1710 12TH AVE.

SDCI# 3036725-LU (3035745-EG)

DESIGN REVIEW BOARD RECOMMENDATION

7.28.2021

1. GASKETS - (PREVIOUS)

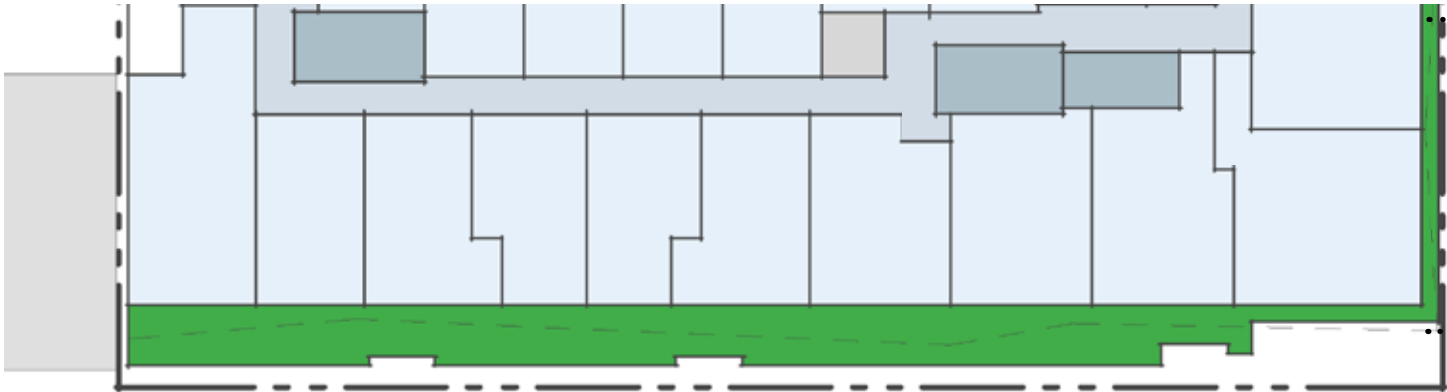
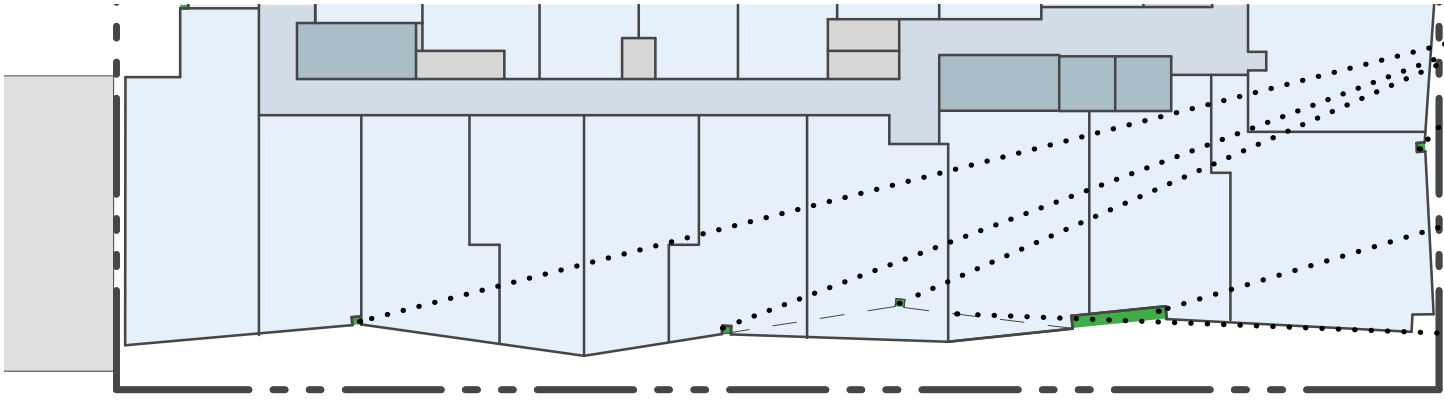
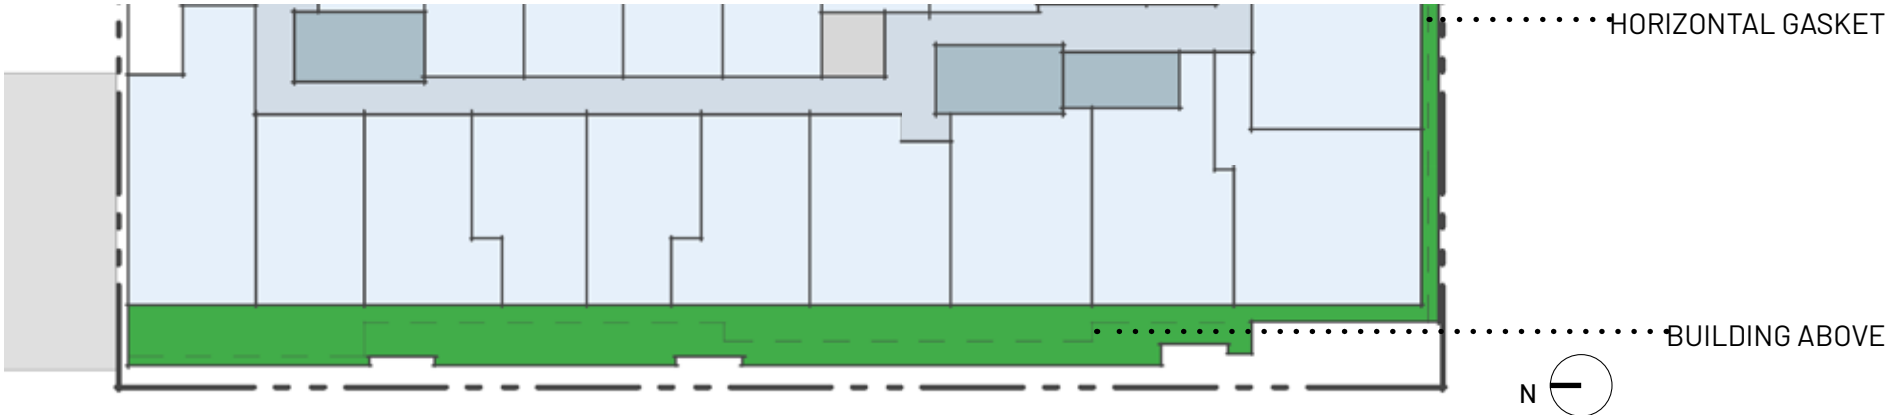
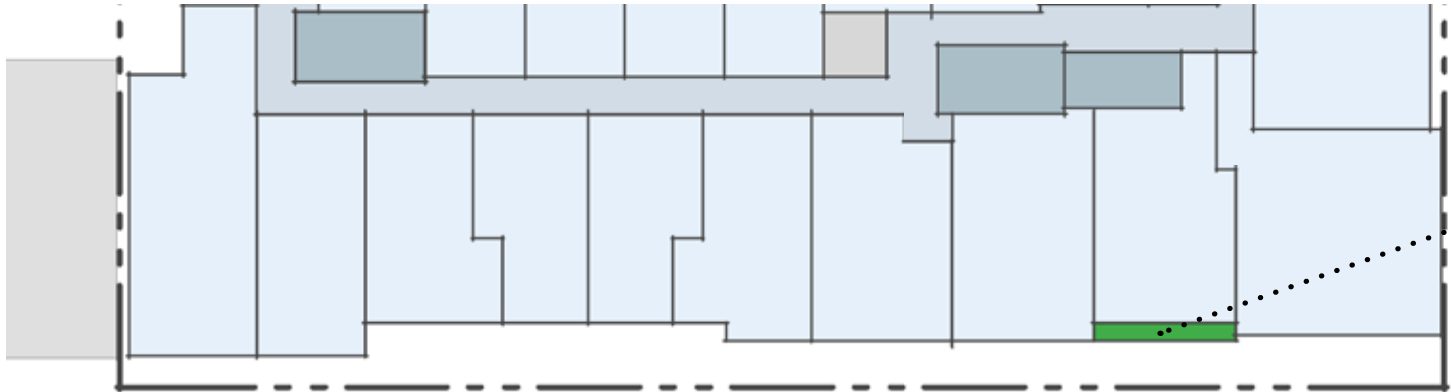
3. **Corner Expression:**
This change to the corner (punched brick proud of facade above) has strengthened its expression but staff recognize the ‘sameness’ this creates at the west facade and street edge. One note: At EDG the Board expressed concern regarding the relentless horizontality of the west facade, and one member suggested variation in the height of the brick bays. A direct response to this guidance could be the corner as four stories (as on page 4) in combination with changing the height of another bay (from 3 to 2?), Particularly as the lowering and raising of the angled facade expression would also address their concern. Possibly worth exploring.

*DRAFT DRB PACKET CORRECTION NOTES FROM PLANNER

- C.2A keeps bays expressed as angled planes woven together on 3 sides and keeps square bay expression only at alley. (See next page for notes regarding studies on different angles.
- C.2A reduces horizontality by deleting horizontal wood gasket, creating verticality with the SW corner brick base height, the full height major gaskets on all sides, and adding secondary minor vertical gaskets to further break the angled planes
- C.2A uses these gaskets and the soffits/parapets to break up the mass into different scale/size elements on the upper levels. The brick base is essentially the same as Option C.1 and is broken into multiple scaled and sized elements. Different elements have different textures of brick detailing as well.
- C.2A keeps the playful angles at the upper floors but keeps them reserved rather than more intense study version shown on next page.

- C.2B takes orthogonal bays from east and incorporates them on other sides of building to create a single language for the project
- C.2B eliminates horizontality by deleting horizontal gasket, creating vertical movement with the SW corner brick base height, the full height major gaskets on all sides, and anchors bays to the top of brick completely separating different areas of the "body" of the building.
- C.2B creates different scaled bays and ganged or un-ganged windows as well as brick base that is expressed at different widths and heights and brick patterns/textures. Materials change and go from pushing outward at upper levels on west to setting back at upper levels on east side.
- C.2B upper levels are quieter / less unique than option C. Potentially distracting less from the activity at street level

4. EAST FACADE - (PREVIOUS)

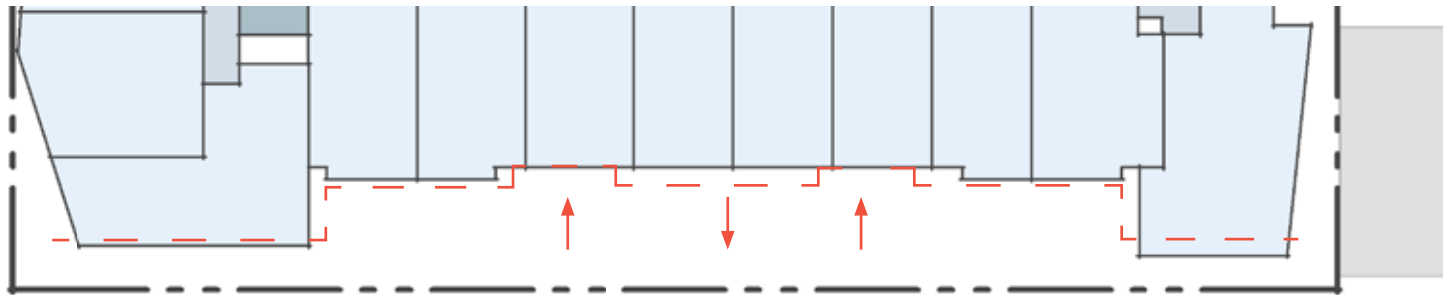
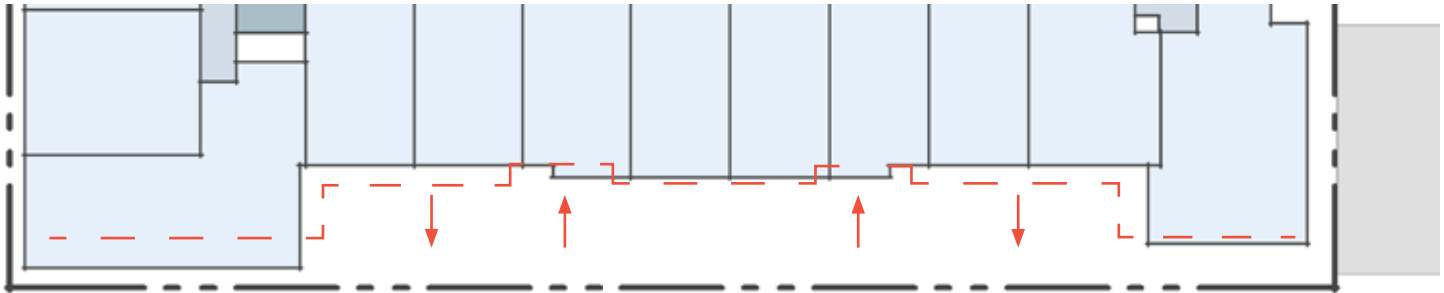
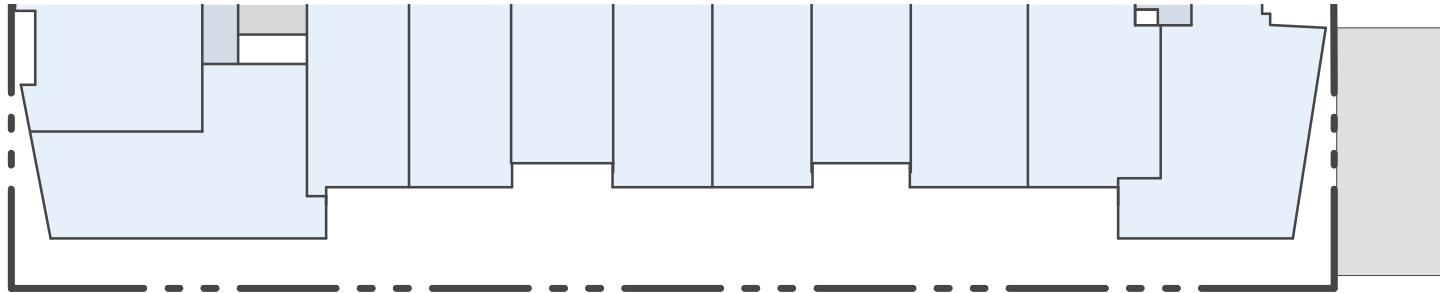
The relocation of the wood material and variation in bay height appear compositionally strong. But the Board may expect a more direct response to their guidance on scale mitigation, such as a portion of the top floor set back significantly to provide relief from the continuous parapet height or similar.

*DRAFT DRB PACKET CORRECTION NOTES FROM PLANNER

ZONE TRANSITION - **SCALE OF CONTEXT**

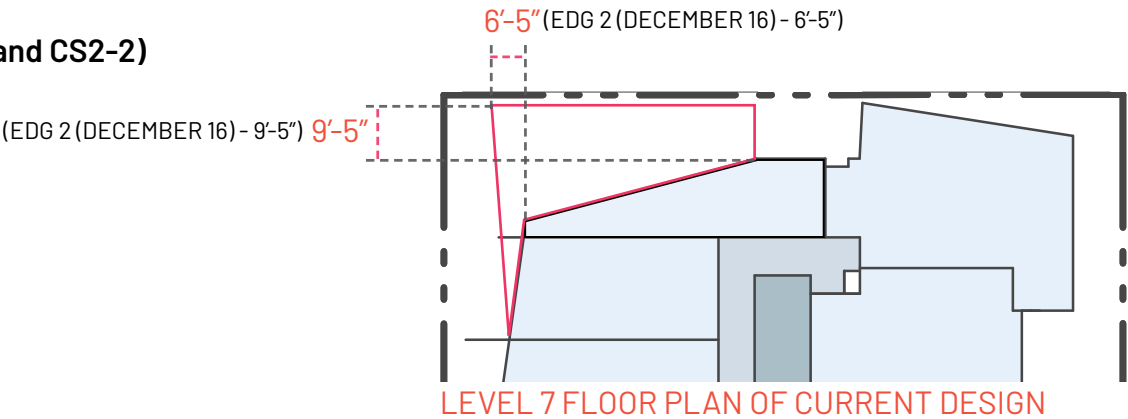
DRB GUIDANCE: The Board noted the setbacks provided at the northwest corner and agreed that a similar approach on the alley facade could help make a better transition to the less intensive zone and mitigate the scale of this significantly larger structure.
(CS2-D, DC2-A, and DC2-B)

RESPONSE:
Both: The corners at the alley have been further eroded and set back while still forming wings that maintain a frame for the courtyard. These erosions paired with the courtyard setbacks and additional upper level setbacks and material changes create a cohesive concept on all facades. This also helps the project meet design goals like providing light and air to neighbors. [CS2-D-5 respect for adjacent sites]. [DC2-A reducing perceived mass]

RELATIONSHIP TO NEIGHBORS

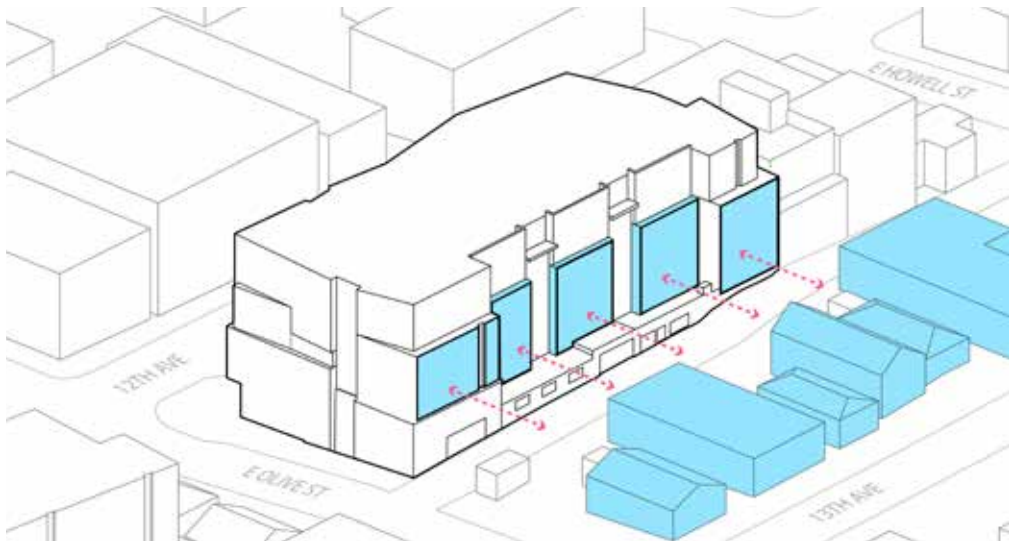
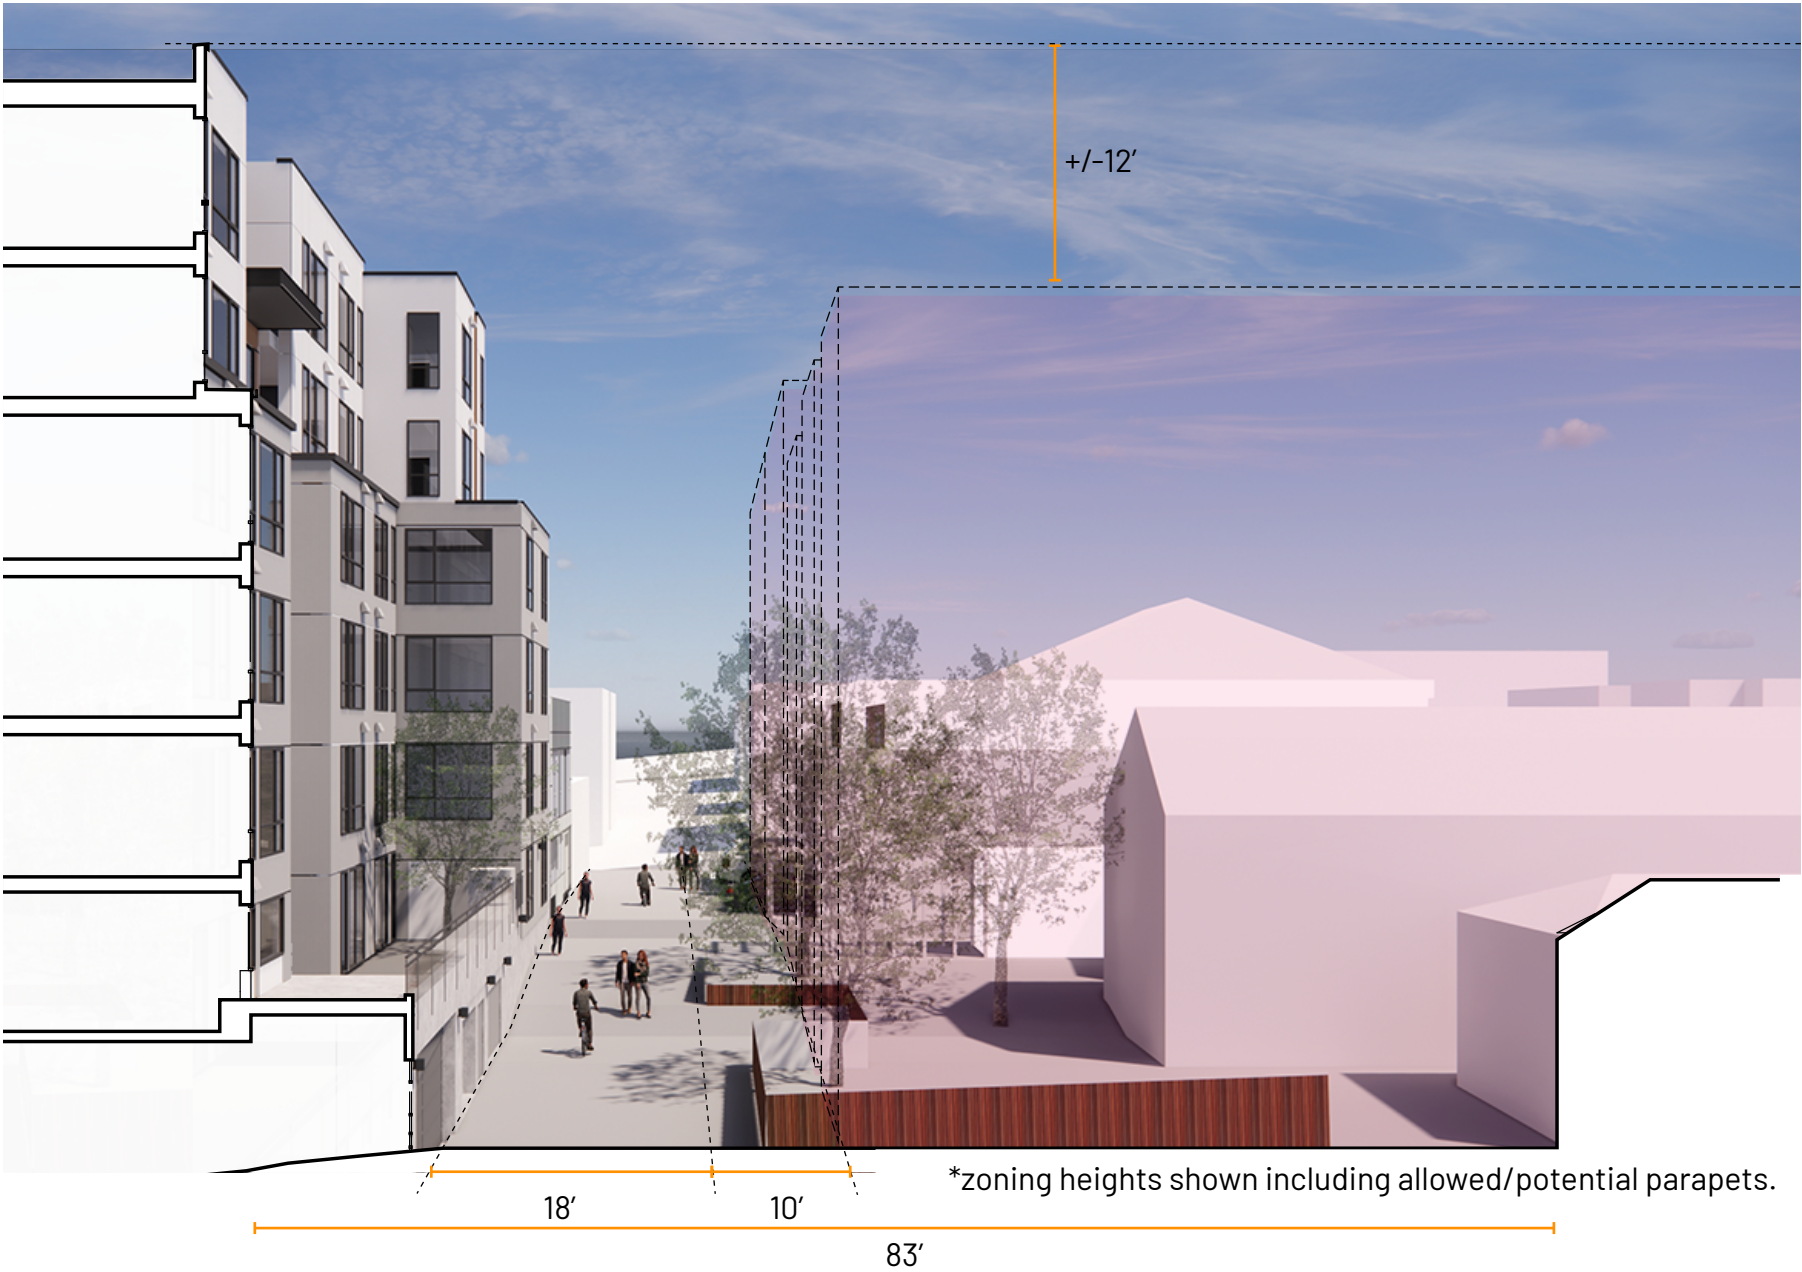
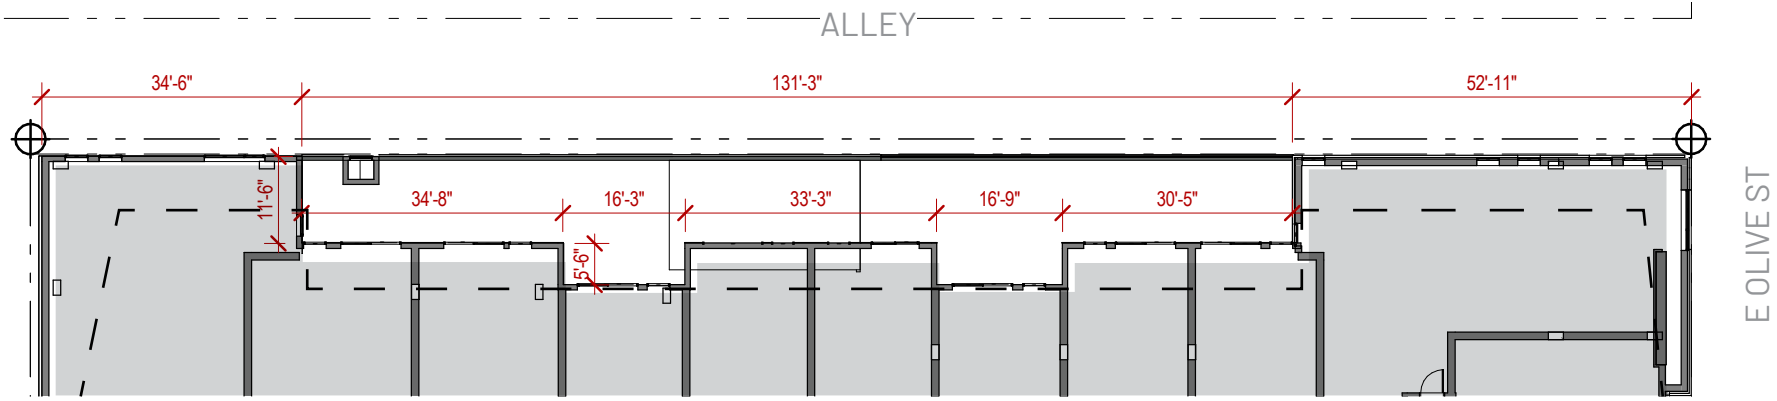
DRB GUIDANCE: Repeating guidance provided at EDG, the Board noted the significant change in zoning from NC3-75 to LR3 at the alley, the length of this transition relative to the smaller platted lots to the east and echoed public comment in identifying this as a critical issue that would require further consideration and refinement to meet criteria in the Guidelines.

RESPONSE:
The zoning change between the NC3-75 to the LR3 (50' height limit) across the alley is 25' in height, but is offset by the natural site topography [DC2-D-2]. The average grade of the project is relatively low due to the elevation of 12th ave while the sites across the alley are 13' to 15' higher leaving a difference between maximum zoning buildable heights of approx. 10 to 12'. The building creates a strong upper level setback at the top two floors (+/- 20 feet below the 75' height limit). This combined with the large courtyard setback, horizontal modulation of deep gaskets forming bays, eroded corners and changes in materials create a massing that not only a transition to the anticipated development potential of adjacent sites [CS2-D-3 & CS2-D-4] but also reflects and respects adjacent current size of neighbors [CS2-D-1]. Widths of bays, detailing of siding, exposed downspouts, expressed roofs, railings, large trees and other planting, windows where possible along alley and the wall of the exposed garage broken up with louvers, garage doors, and alcoves create a buffer to nearby buildings [CS2-D-5, DC2-B-1, DC2-B-2]
